Product Change Notice (PCN)

Subject: Change Shipping Media on Select Package

Publication Date: 12/8/2020

DRAWING NO. MSC-8603-A

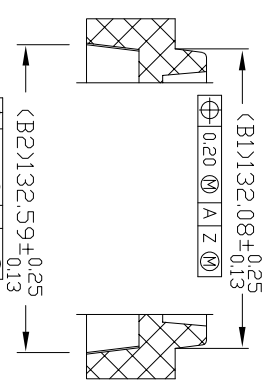
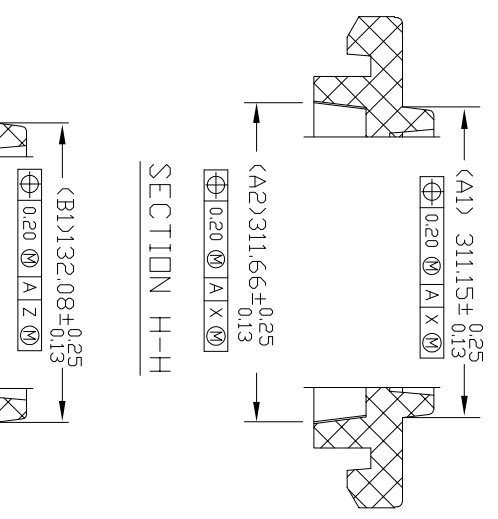
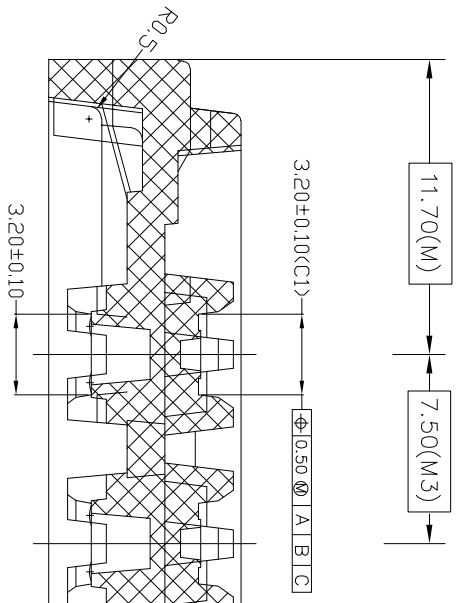
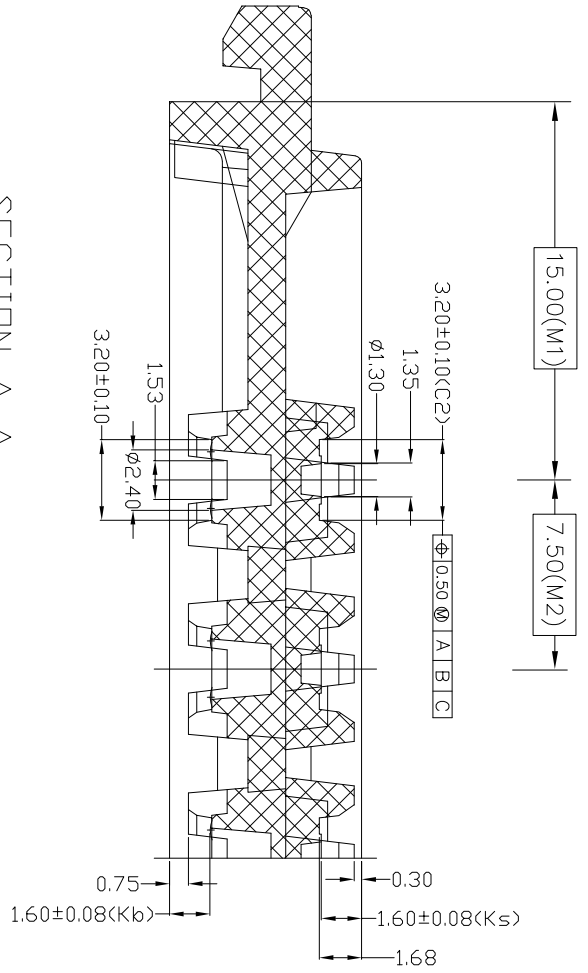
Renesas is converting shipping media from Tube to Tray on package QFN 3mm x 3mm and QFN 4mm x 4mm. The current shipping media in Reel remains unchanged. Industrial standard JEDEC shipping trays will be introduced. Refer Appendix B for tray drawings.
